**Addendum s to
ASHRAE Guideline 36-2018**

Proposed Addendum s to Guideline 36-2018, High-Performance Sequences of Operation for HVAC Systems

**First Public Review (November 2020)
(Draft shows Proposed Changes to Current Guideline)**

This addendum is to resolve the issues related to minimum outdoor airflow control for multiple zone air handling units with return fans. This addendum also provides clarification on building pressure control for return fans and adds informative text for the designer with respect to defining pressure zones.

Figure 5.16.2.3-1 SAT loop mapping with relief damper or relief fan.

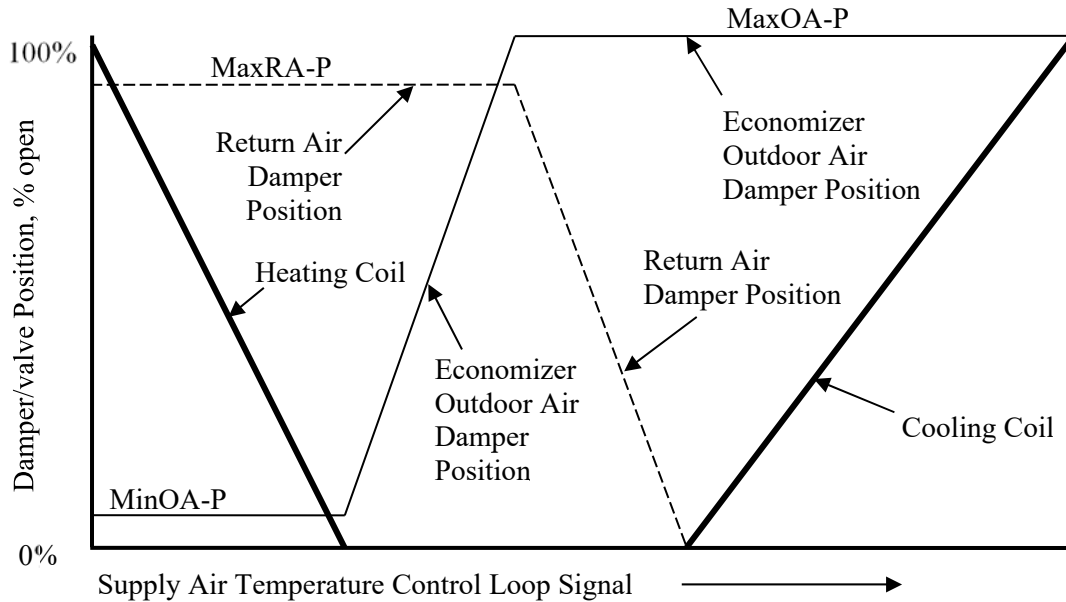
For AHUs with relief fans, outdoor air and return air dampers are sequenced rather than complementary (as per traditional sequences) to reduce fan power at part loads.

Figure 5.16.2.3-2 SAT loop mapping with return-fan control with airflow tracking.

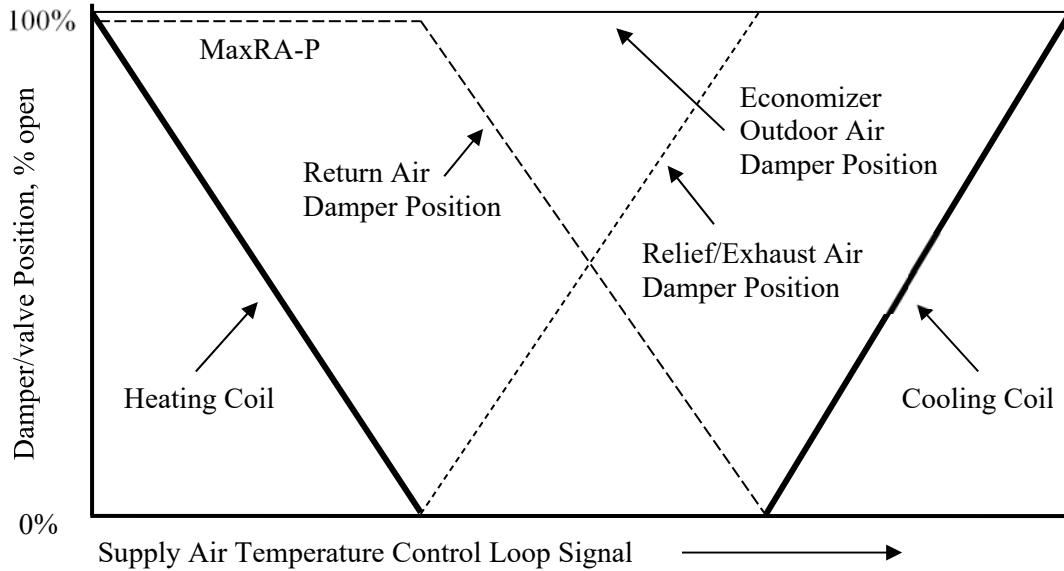
For AHUs with return fans and airflow tracking control, the SAT control loop makes the economizer outdoor air damper open fully whenever the AHU is on, while the return air damper modulates to maintain supply air temperature as shown below. Relief/exhaust damper position tracks inversely with the return damper position.

Outdoor air dampers on air handlers with return fans have no impact on the outdoor airflow rate into the mixing plenum. Instead, the return-fan and return-damper controls dictate outdoor air flow. See ASHRAE Guideline 16.

Note that the economizer damper will close (if there is a separate minimum outdoor air damper) or modulate to minimum position (if there is a single outdoor air damper) whenever minimum outdoor air control is active. See logic for Minimum Outdoor Air Control below.

Figure 5.16.2.3-3 SAT loop mapping with return-fan control with direct building pressure controls.

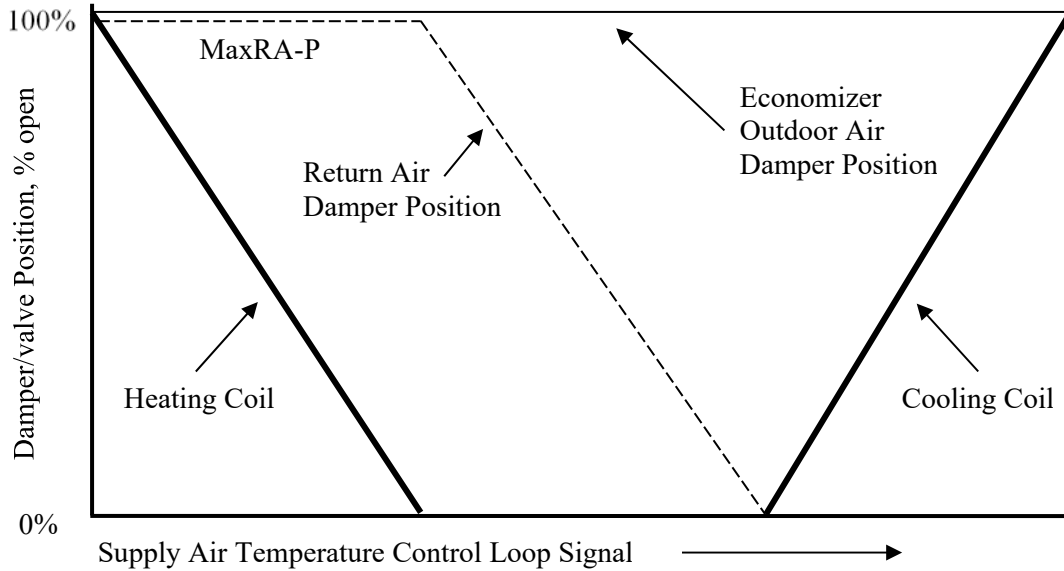
For AHUs with return fans and direct building pressure controls, the SAT control loop makes the economizer outdoor air damper open fully whenever the AHU is on, while the return air damper modulates to maintain supply air temperature as shown below. Relief/exhaust damper position tracks inversely with the return damper position.

Outdoor air dampers on air handlers with return fans have no impact on the outdoor airflow rate into the mixing plenum. Instead, the return-fan and return-damper controls dictate outdoor air flow. See ASHRAE Guideline 16.

Note that the economizer damper will close (if there is a separate minimum outdoor air damper) or modulate to minimum position (if there is a single outdoor air damper) whenever minimum outdoor air control is active. See logic for Minimum Outdoor Air Control below.

Figure 5.16.6.3 Minimum outdoor airflow control mapping with single damper.

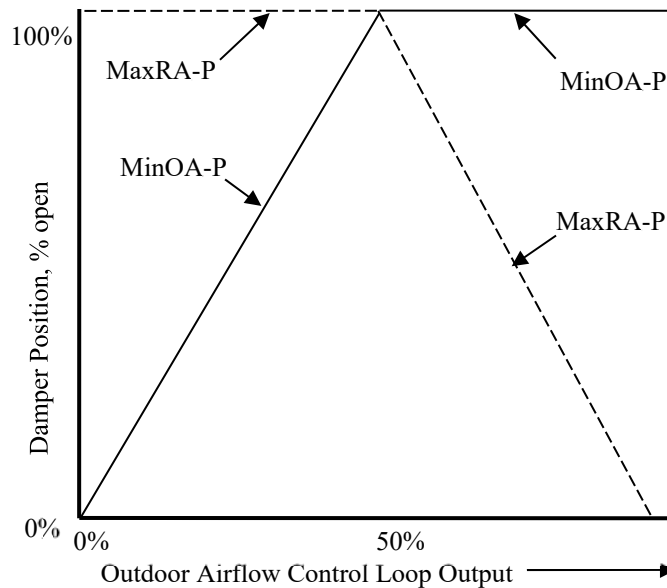
1. The outdoor airflow rate shall be maintained at the minimum outdoor air set point MinOAsp by a reverse-acting control loop whose output is mapped to economizer damper minimum position MinOA-P and return air damper maximum position MaxRA-P as indicated in Figure 5.16.6.3.

Figure 5.16.10.5 Exhaust damper position and return-fan DP reset

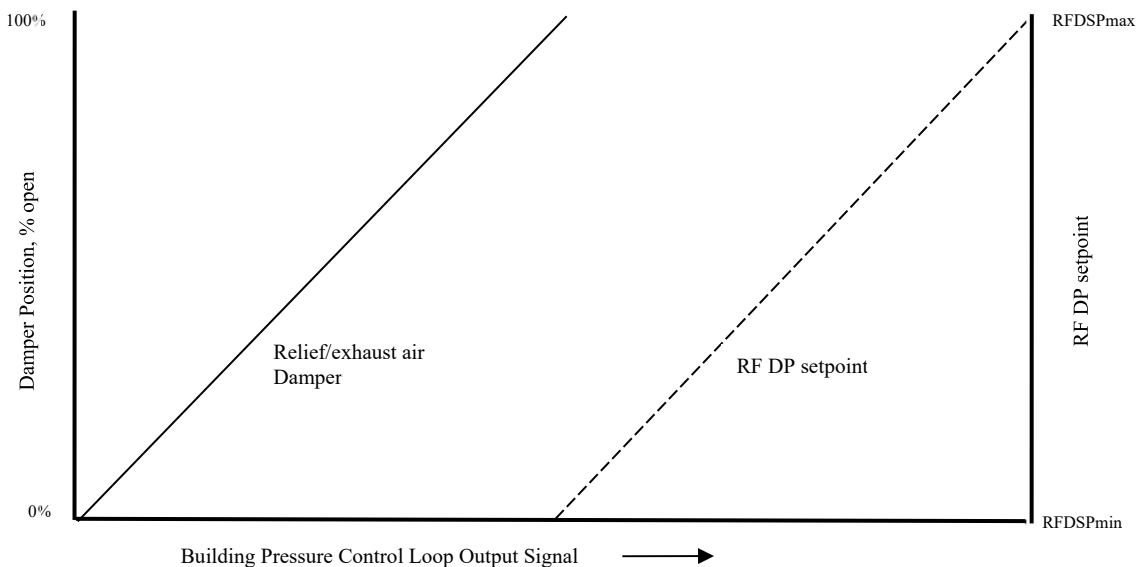
5.16.10.5.16.10.4 A single P-only control loop for each pressure zone shall modulate to maintain the building pressure at a setpoint of 12 Pa (0.05 in. of water) with an output ranging from 0% to 100%. The loop shall be enabled when the supply and return fans for any unit within the pressure zone are proven ON and the minimum outdoor air damper is open. The exhaust dampers shall be closed with loop output set to zero otherwise. All exhaust damper and return fan static pressure setpoints for units in an associated pressure zone shall be sequenced based on building pressure control loop output signal, as shown in Figure 5.16.10.5. When exhaust dampers are enabled, a control loop shall modulate exhaust dampers in sequence with the return fan static pressure set point, as shown in Figure 5.16.10.5, to maintain the building pressure at a set point of 12 Pa (0.05 in. of water).

- a. From 0% to 50%, the building pressure control loop shall modulate the exhaust dampers from 0% to 100% open.
- b. From 51% to 100%, the building pressure control loop shall reset the return-fan discharge static pressure set point from RFDSPmin at 50% loop output to RFDSPmax at 100% of loop output. See Section 3.2.1.4 for RFDSPmin and RFDSPmax.
